STRATHFIELD COUNCIL **APPROVAL** DA2015/100/03 Date: 20/12/2017

S96 NOTES:

PROPOSED RESIDENTIAL DEVELOPMENT 84 CENTENARY DRIVE, STRATHFIELD NSW 2135 CHECKED BY: NM DATE: 038-S96-04 JULY 2017

Ground Floor Building B

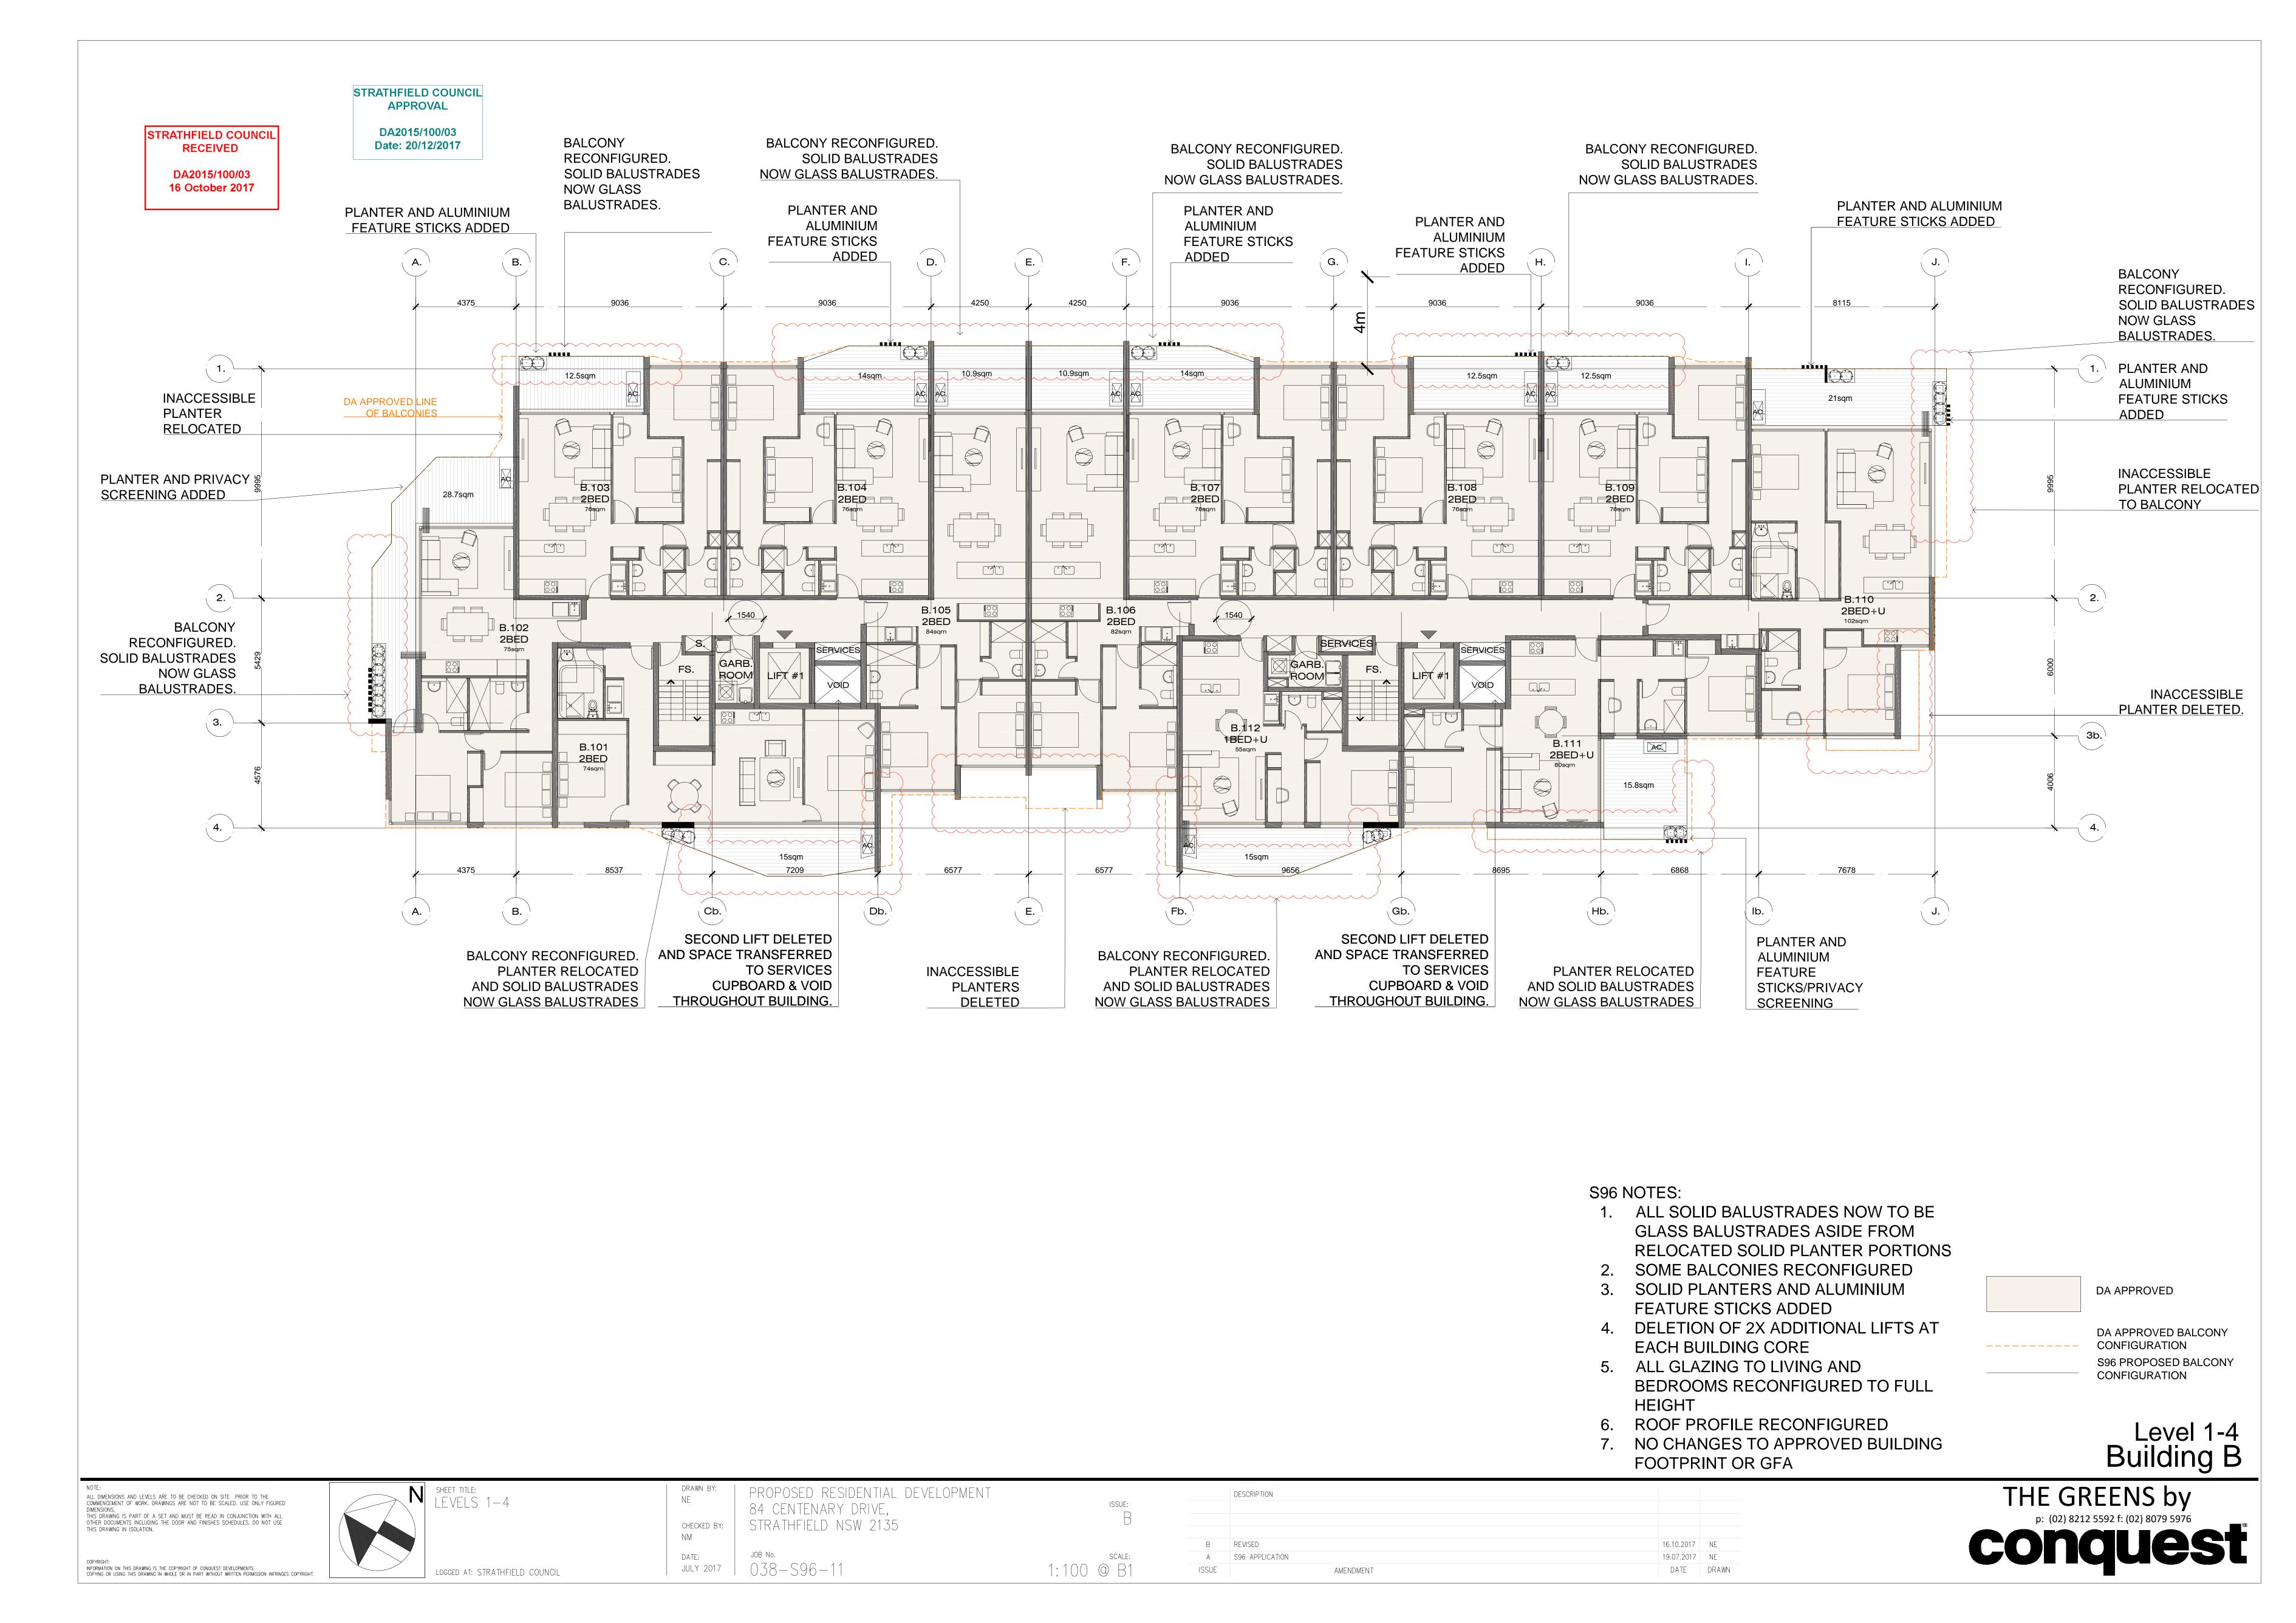
- 1. ALL SOLID BALUSTRADES NOW TO BE GLASS BALUSTRADES ASIDE FROM RELOCATED SOLID PLANTER PORTIONS
- 2. SOME BALCONIES RECONFIGURED
- 3. SOLID PLANTERS AND ALUMINIUM FEATURE STICKS ADDED
- 4. DELETION OF 2X ADDITIONAL LIFTS AT EACH BUILDING CORE
- 5. ALL GLAZING TO LIVING AND BEDROOMS RECONFIGURED TO FULL HEIGHT
- 6. ROOF PROFILE RECONFIGURED
- 7. NO CHANGES TO APPROVED BUILDING FOOTPRINT OR GFA

DA APPROVED BALCONY CONFIGURATION S96 PROPOSED BALCONY CONFIGURATION

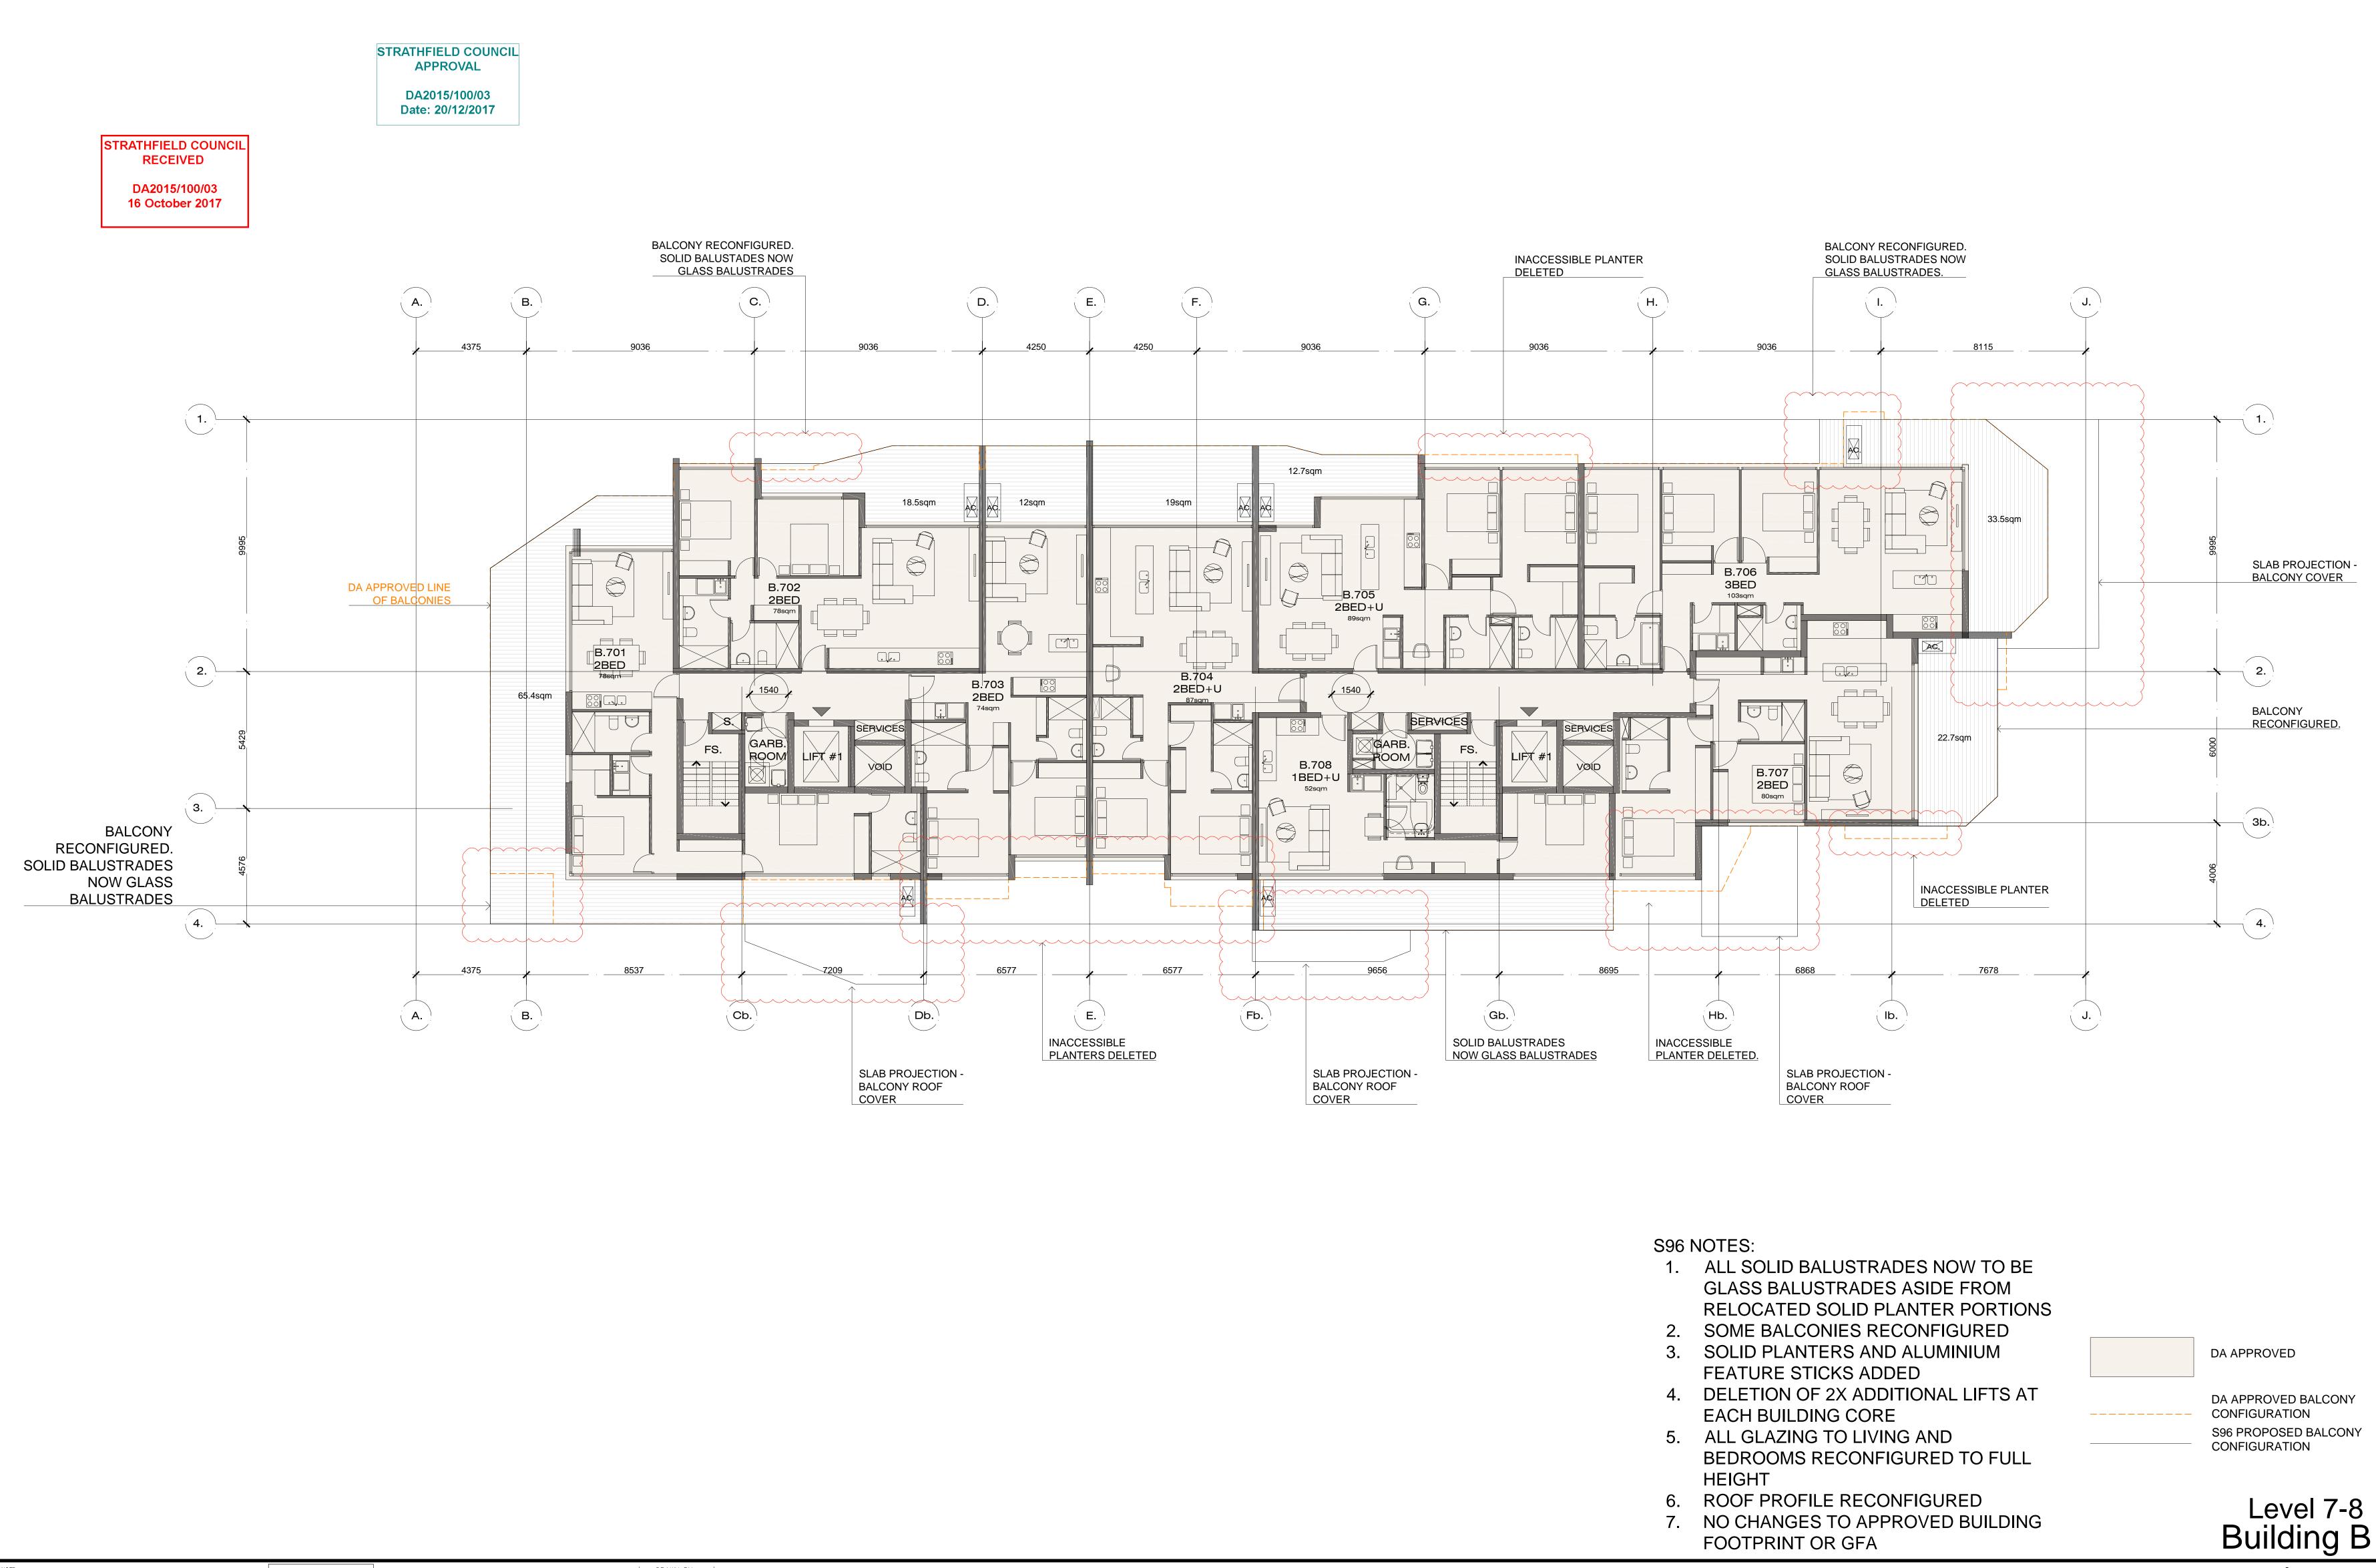
STRATHFIELD COUNCIL **APPROVAL** DA2015/100/03 Date: 20/12/2017 **SLAB PROJECTION -**STRATHFIELD COUNCIL RECEIVED BALCONY COVER DA2015/100/03 16 October 2017 INACCESSIBLE PLANTER DELETED. BALCONY RECONFIGURED. PLANTER AND **INACCESSIBLE INACCESSIBLE** SOLID BALUSTRADES PLANTER DELETED, PLANTER AND ALUMINIUM ALUMINIUM FEATURE PLANTER DELETED. NOW GLASS BALUSTRADES. STICKS ADDED BALCONY RECONFIGURED. **BALCONIES RECONFIGURED** FEATURE STICKS ADDED (D.) G. 4375__ 4250 1. 27.7sqm DA APPROVED LINE **BALCONY** B.507 3BED RECONFIGURED. B.506 SOLID BALUSTRADES 2BED+U **NOW GLASS** BALUSTRADES. 2BED+U B.505 3BED 80sqm 3. B.510 1BED+U B.509 3b. 2BED 1BED INACCESSIBLE PLANTER DELETED 4. 4. 14.5sqm 7678 Hb. SECOND LIFT DELETED **INACCESSIBLE** BALCONY RECONFIGURED AND SPACE TRANSFERRED PLANTER DELETED. SOLID BALUSTRADES SECOND LIFT DELETED TO SERVICES BALCONY RECONFIGURED. **BALCONY NOW GLASS** AND SPACE TRANSFERRED CUPBOARD & VOID **ALUMINIUM FEATURE** RECONFIGURED. BALUSTRADES. TO SERVICES THROUGHOUT BUILDING. STICKS ADDED SOLID BALUSTRADES **ALUMINIUM FEATURE CUPBOARD & VOID NOW GLASS** STICKS ADDED THROUGHOUT BUILDING. BALUSTRADES **INACCESSIBLE PLANTERS** DELETED S96 NOTES: 1. ALL SOLID BALUSTRADES NOW TO BE GLASS BALUSTRADES ASIDE FROM RELOCATED SOLID PLANTER PORTIONS 2. SOME BALCONIES RECONFIGURED 3. SOLID PLANTERS AND ALUMINIUM DA APPROVED FEATURE STICKS ADDED 4. DELETION OF 2X ADDITIONAL LIFTS AT DA APPROVED BALCONY EACH BUILDING CORE CONFIGURATION S96 PROPOSED BALCONY 5. ALL GLAZING TO LIVING AND CONFIGURATION BEDROOMS RECONFIGURED TO FULL HEIGHT 6. ROOF PROFILE RECONFIGURED Level 5-6 Building B 7. NO CHANGES TO APPROVED BUILDING FOOTPRINT OR GFA THE GREENS by p: (02) 8212 5592 f: (02) 8079 5976 SHEET TITLE: LEVELS 5-6 DRAWN BY: PROPOSED RESIDENTIAL DEVELOPMENT DESCRIPTION ISSUE: 84 CENTENARY DRIVE, STRATHFIELD NSW 2135 CHECKED BY:
